Subject: Airbrakes actuation shaft

Affected: Kestrel

At every annual inspection, check the welding joint area of the airbreak actuation lever on the torsion tube according to TN 401-26.

Material: See drawing no. 401-56-3-1

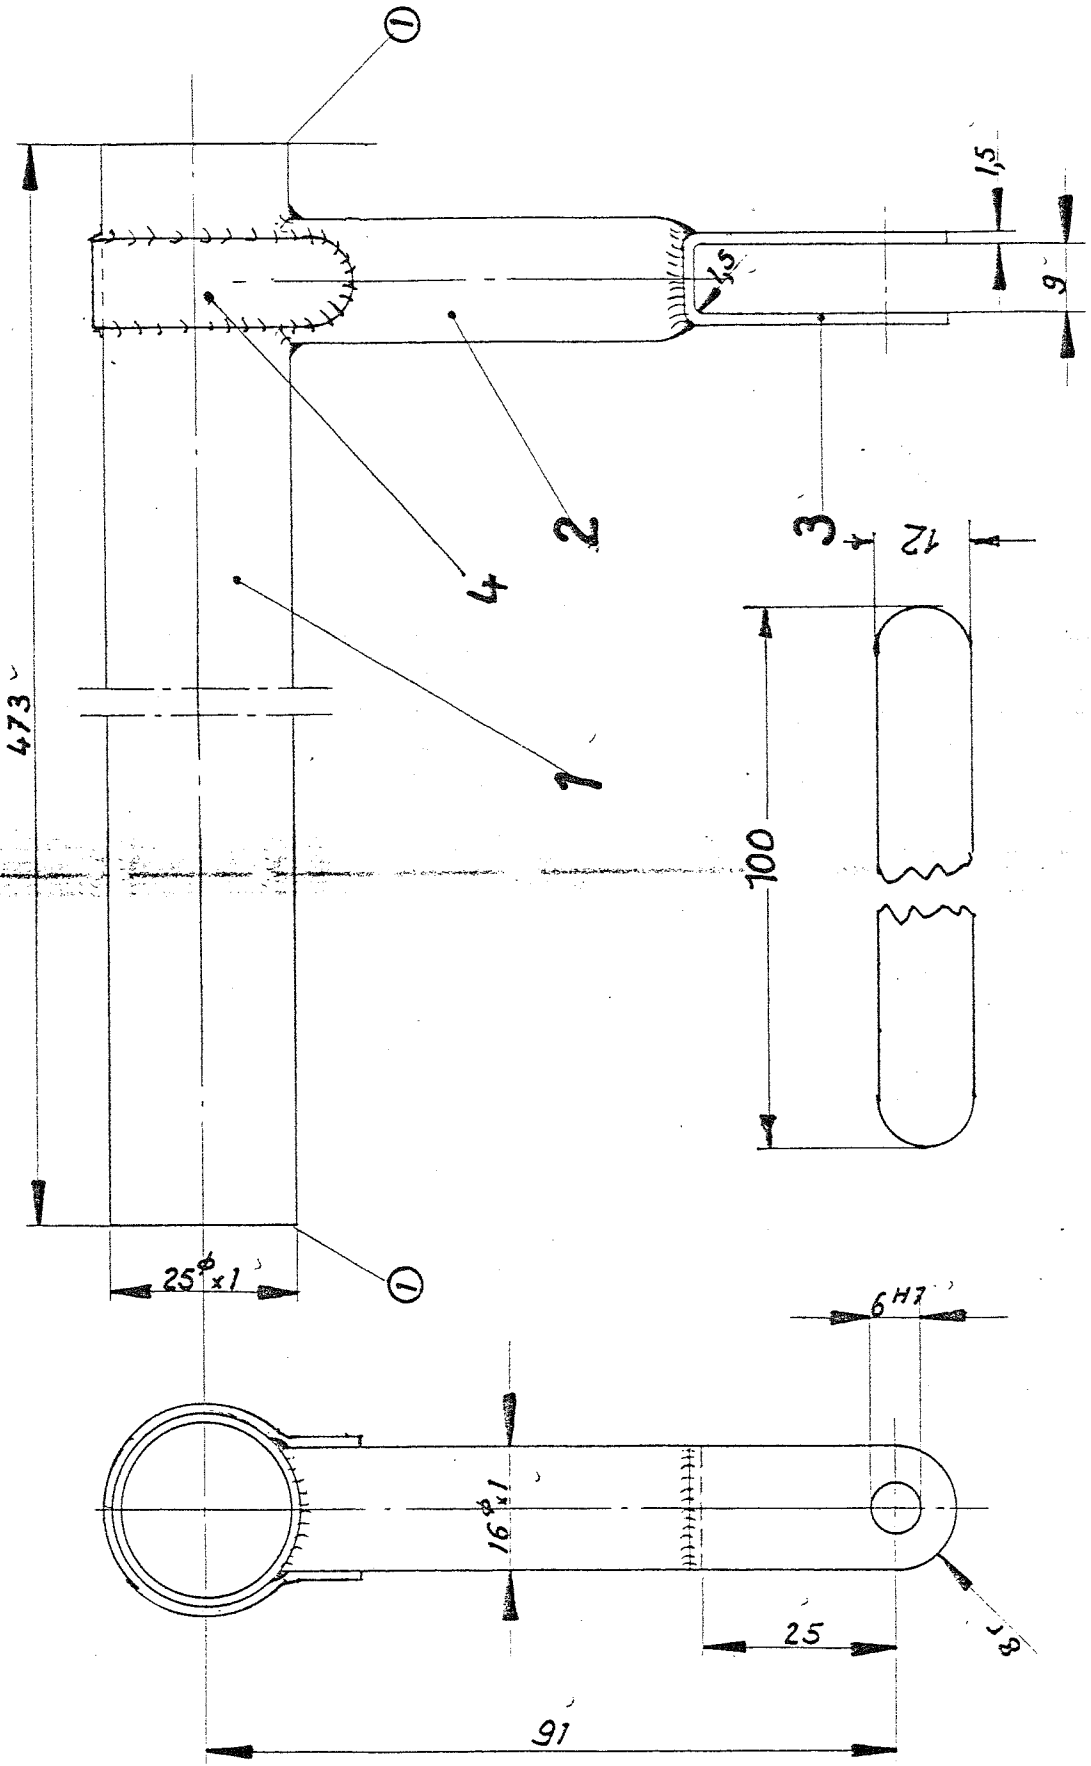
Action 1. Visually check the area of the welding seam between actuation lever and torsion shaft  
2. Insert page 27d into the flight manual  
3. Visually check the area mentioned in step 1 at each annual inspection

4. If damage is found during completion of step 1 or 3, the airbrake actuation shaft must be immediately removed. The welding seam area must be thoroughly cleaned and all paint removed. In case of visible deformation, the actuation lever must be heated and returned to the original position. Visible cracks may only be welded by a licensed aircraft welder within a licensed and appropriately equipped aircraft maintenance organisation. Afterwards no. 4 must be properly welded in accordance with drawing no. 401-56-3-1.  
Welding joints must be done with the WIG-inert protective atmosphere welding system with welding material 1.7734.2. Finally the actuation shaft must be finished with primer and paint RAL 7003. After assembly, you must check that both airbrakes are completely locked and past the over center. This can be done by visually inspection through the hole in the root rib both airbrake actuators must be positioned against their stops.

At the same time the airbrake handle should be in the detent. The force needed to lock and unlock the spoilers should not be more than 20 daN (44lb). If the forces are too high, the length of the control rod in the fuselage may need to be adjusted.
